PLANNING BOARD AGENDA
JUNE 12, 2019 – 6:00 P.M.

RE: **Response to Comments**
March 2019 Planning Board Meeting
Action Fuel 16 State Route 6N
Proposed Propane Storage and Distribution Facility
Town of Carmel, Putnam County

Alliance Environmental Group/An F.W. Webb Company (AEG/F.W. Webb) is responding to comments from the March 2019 Planning Board Meeting. The application was submitted for the proposed construction of a propane distribution facility at the property located at 16 State Route 6N in the Town of Carmel, New York (the "Site"). Applicable responses are presented in the below sections.

SCALE	PROJECT NO.	DRAWING NUMBER
AS NOTED	2804	C102

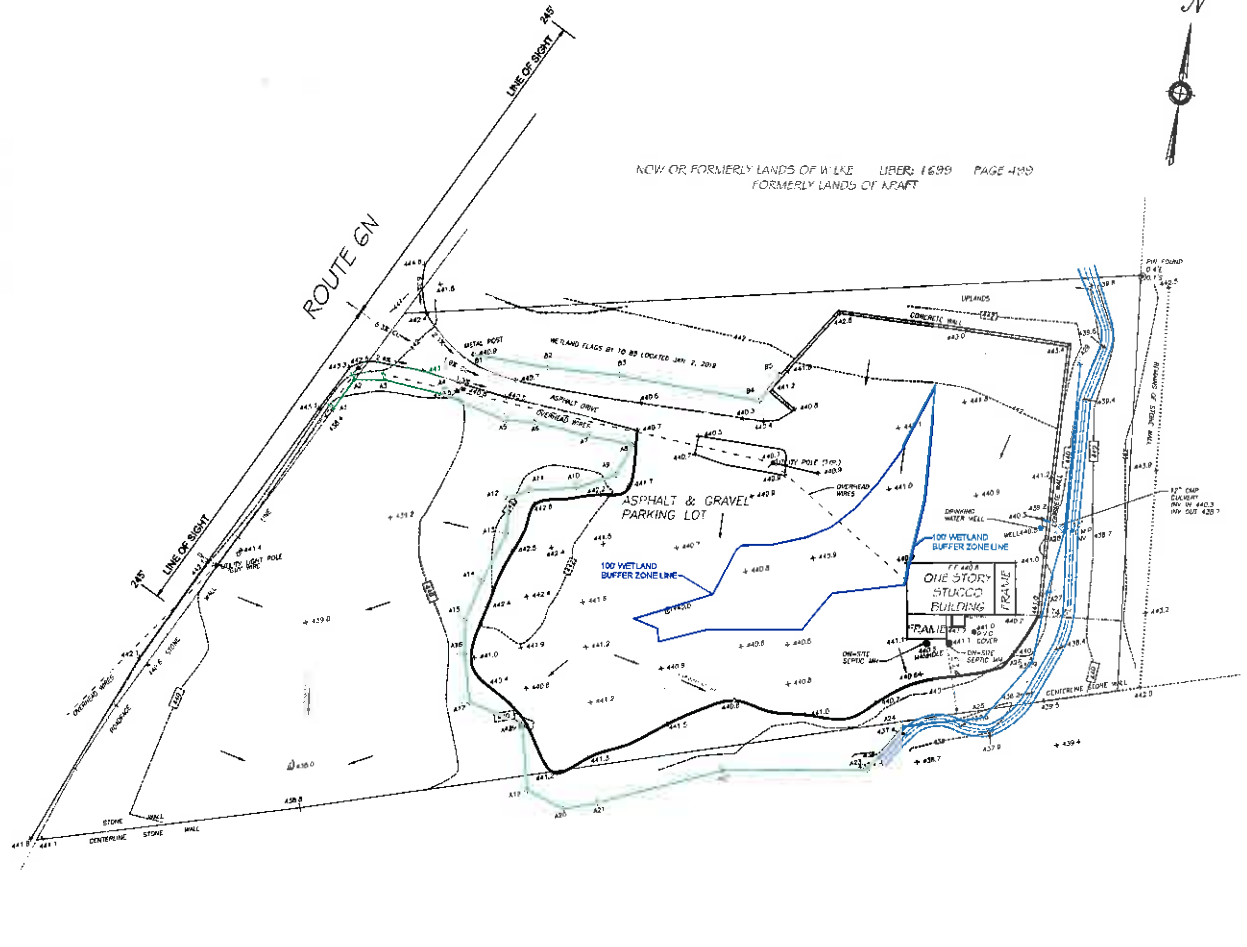
Sheets C-102 and C-103 of the May 2019 Plan Set depict the existing and proposed conditions at the Site. Since the Site is relatively flat, the construction of the proposed propane system will have no effect on the grades at the Site. As part of the wetlands permit, NYDEC has requested that the excavated soil be taken off-Site for reuse at another facility owned by the Site owner.

PROPOSED CONDITIONS	
ACTION FUEL 18 ROUTE 6N (MAHOPAC) CARMEL, NY 10641	
PROJECT NO.	DRAWING NUMBER
Z904	C103

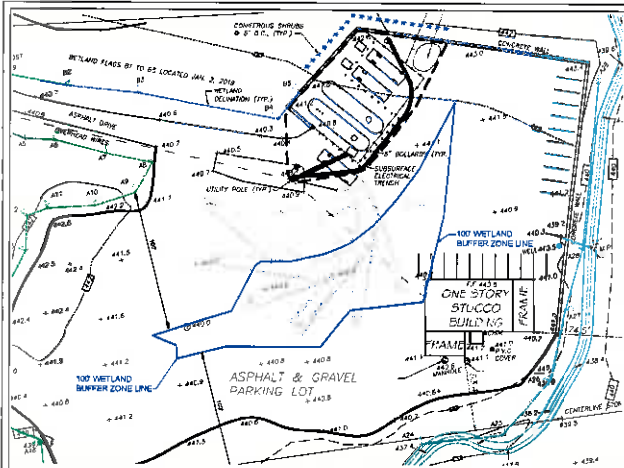
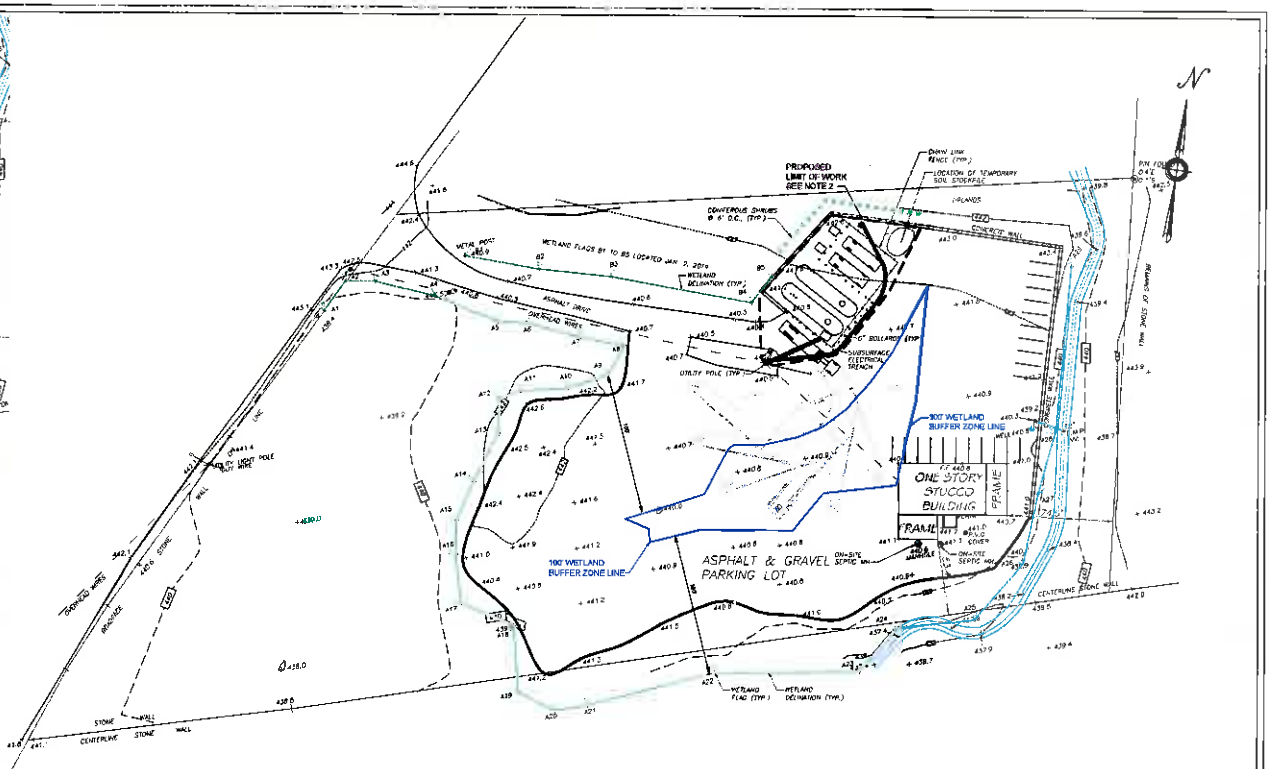
As presented in Table 6.3.1.1 in NFPA 58, the proposed bulk propane facility must be 50 feet or more from the property line. The May 2019 plan set shows that both tanks are located more than 50 feet from the northern property line.

Lighting and Lighting Spill Plan

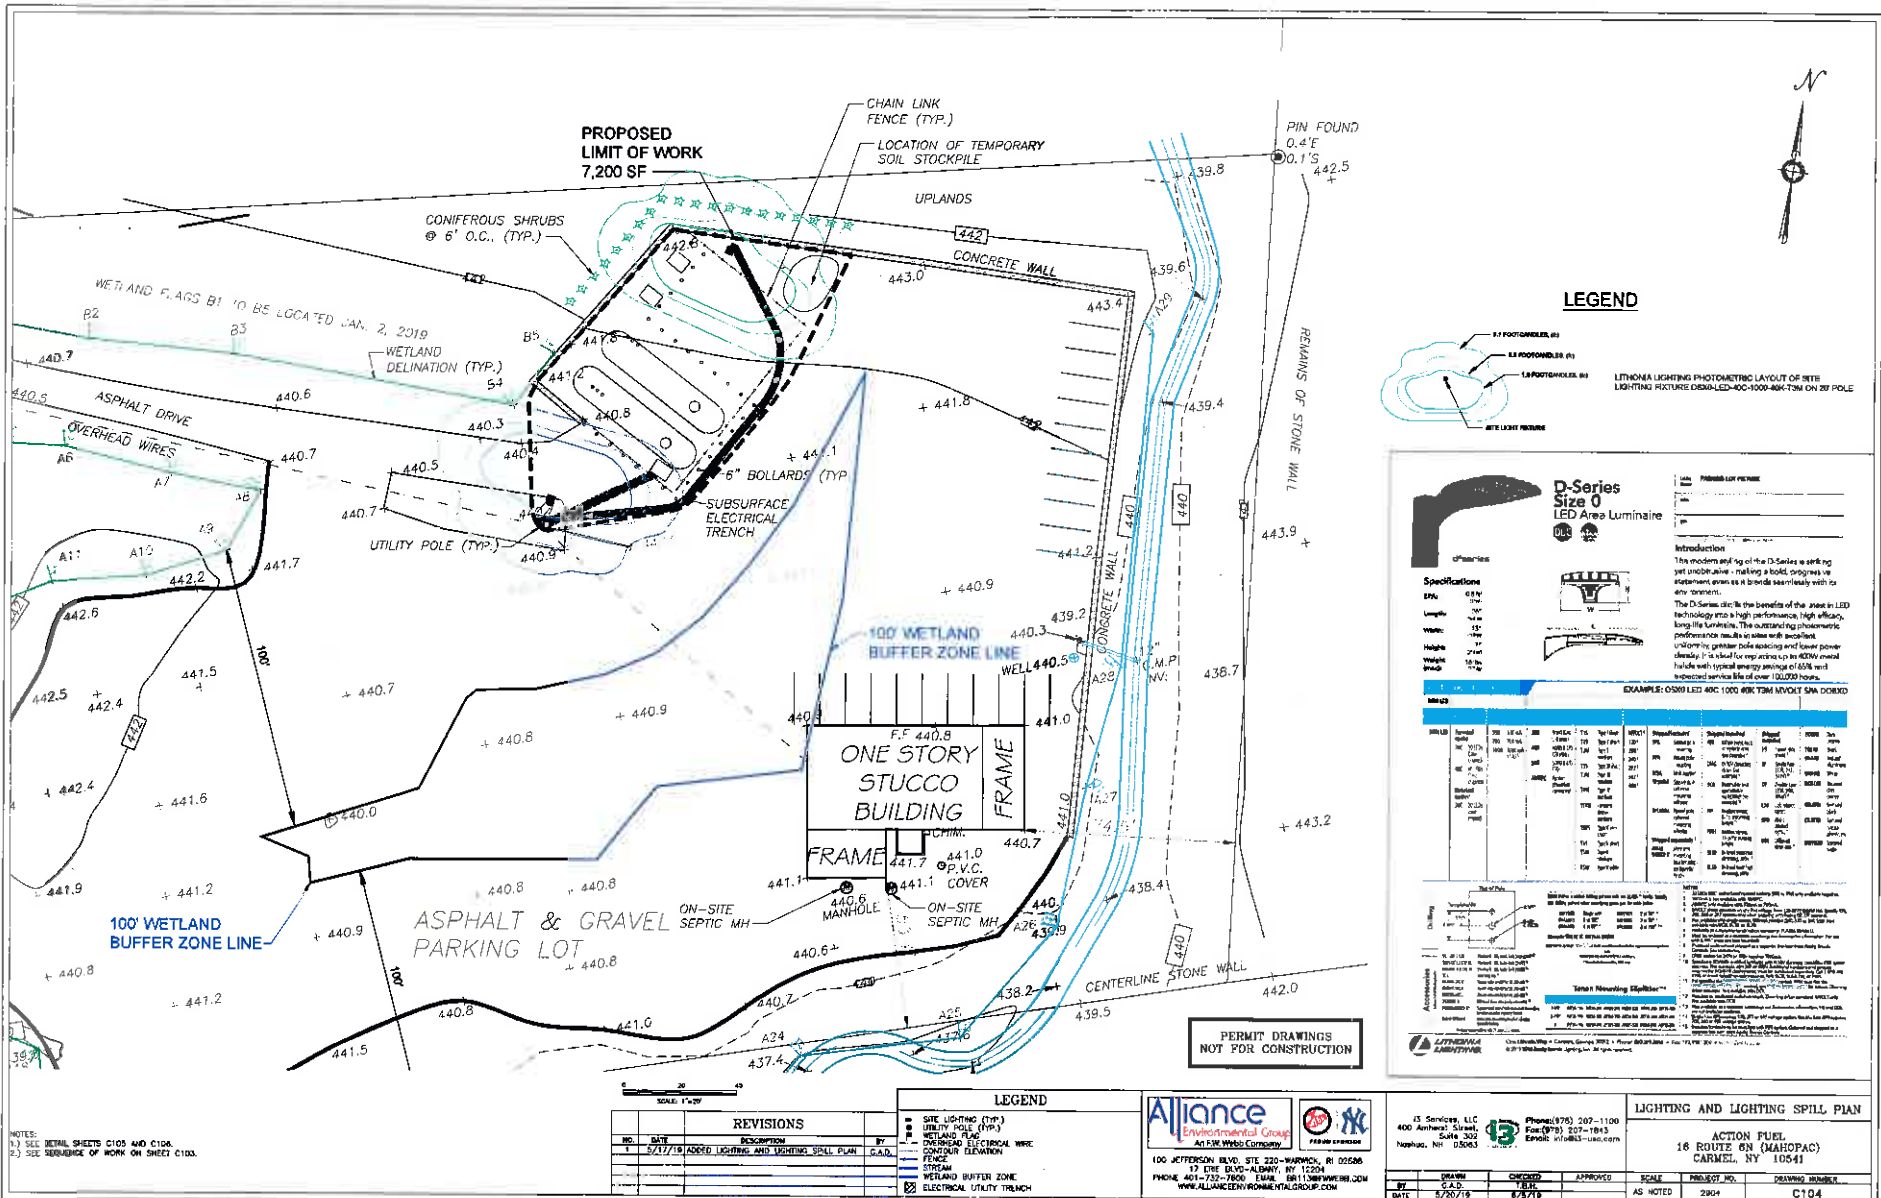
The propane facility will be fenced for security with manned operation only. A lighting and spill plan are included in the May 2019 plan set.
